DOCUMENT CHANGE REQUEST

DCR number 371

Title: CMOS 8-Stage Shift and Store Bus Register with Synchronous Serial Outputs and 3-State Parallel

Number: 9306/026

TIMING DIAGRAM

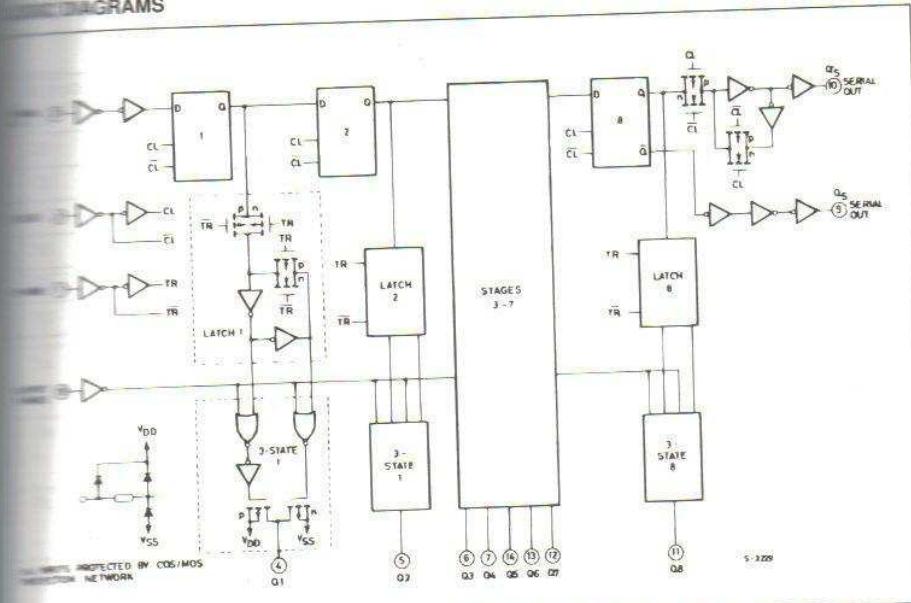
timing diagram is wrong.

during migration from old ESA/SCC form to ESCC form, the diagram was copied and an error was introduced: the second negative pulse of STR shall start at the next falling front of CLK (in the same time as OE).

Good diagram is proposed in attached file
